AMENDMENT NO. 1
TO THE
FINAL DRAINAGE REPORT
FOR
TIMBERLINE STORAGE YARD
EL PASO COUNTY, COLORADO

SEPTEMBER 2019

PCD Project No. PPR-17-018 /PPR-19-042

Detention Basin Outlet Structure Design

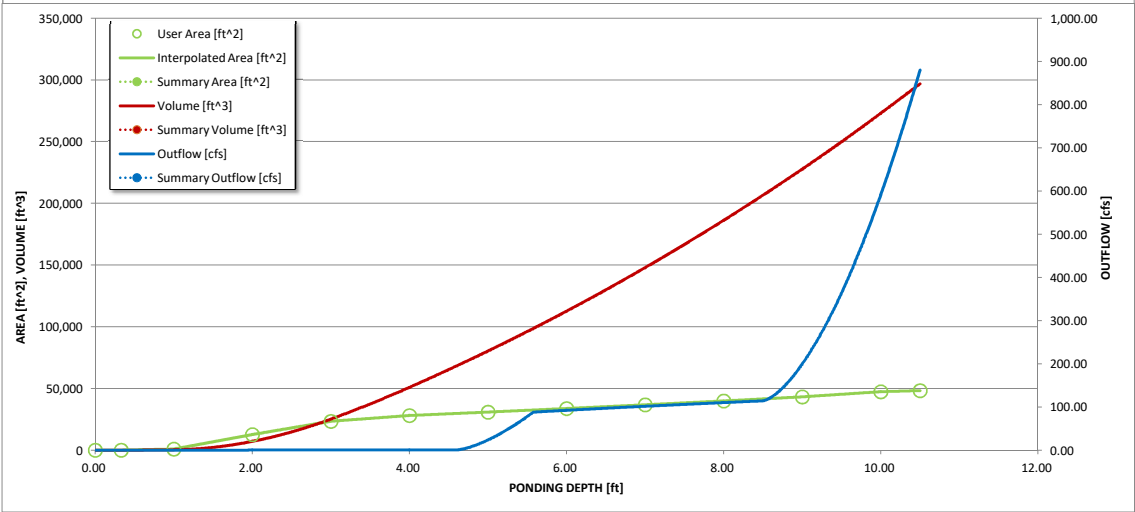
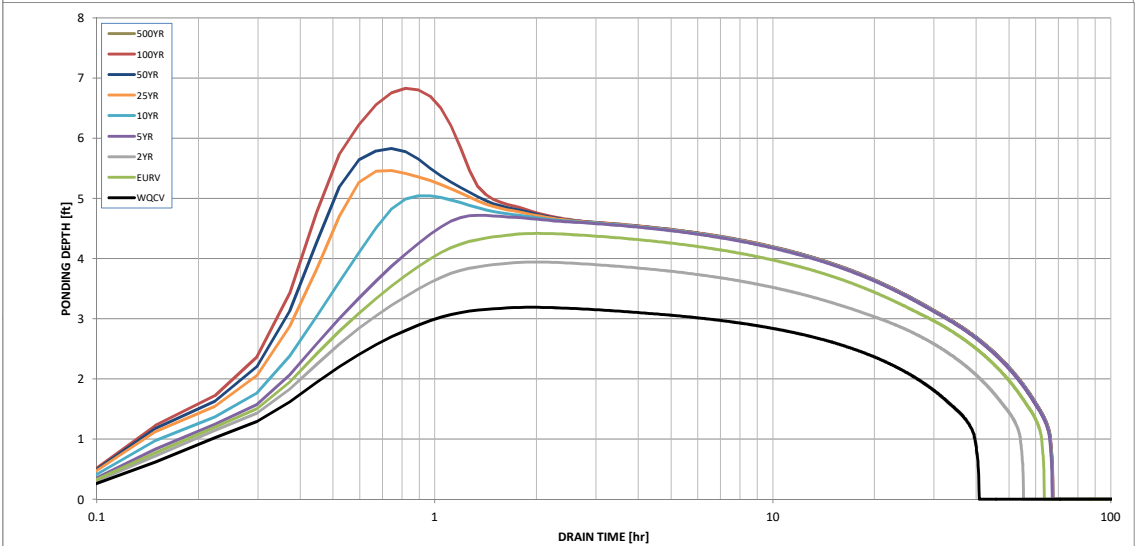
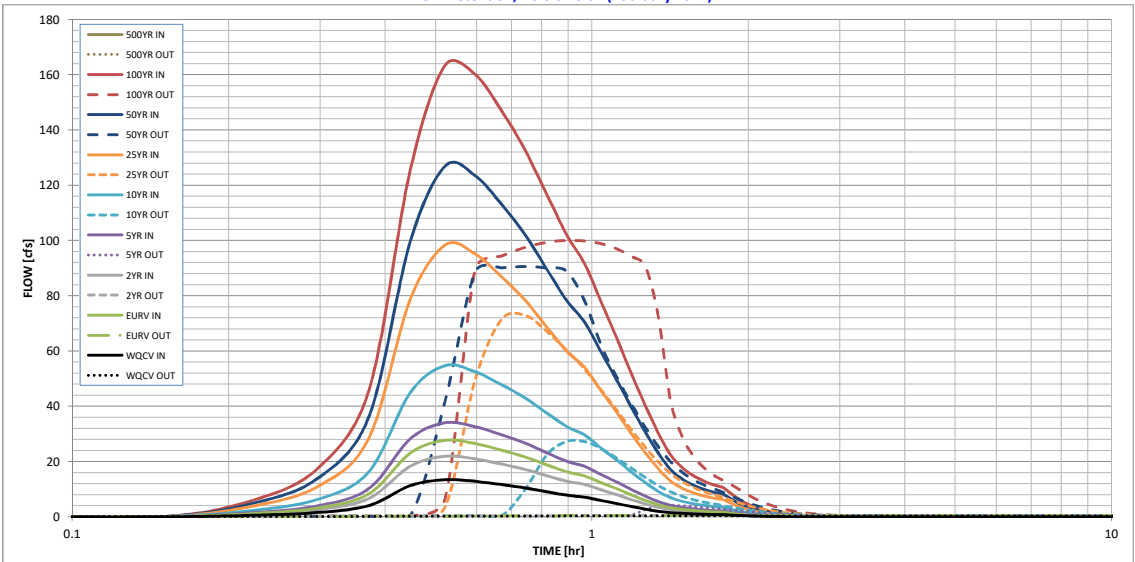
fix

Stormwater Detention and Infiltration Design Data Sheet

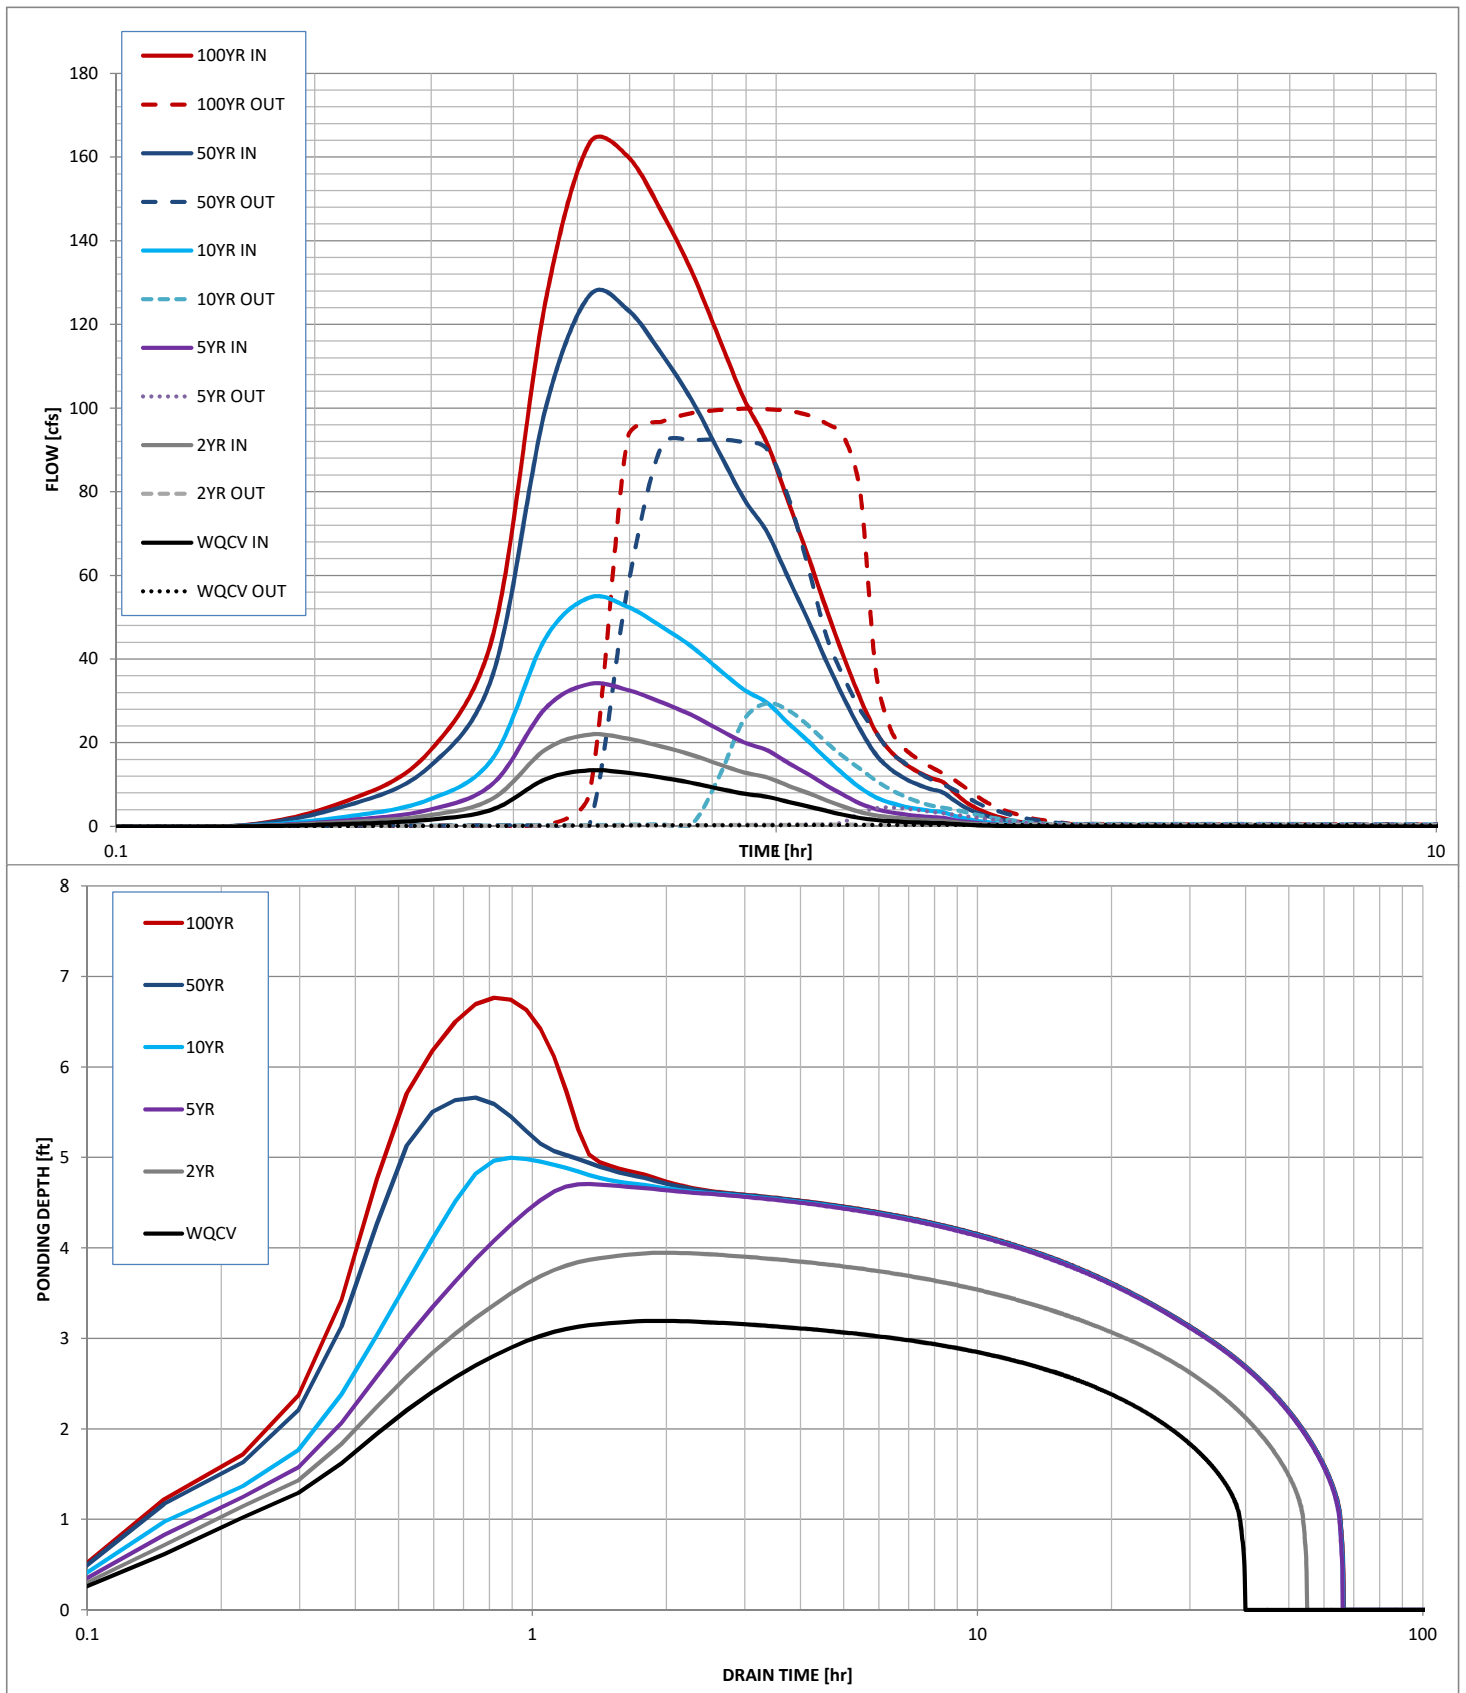
- soil groups A and B?

attach the pdf of this worksheet to that record.
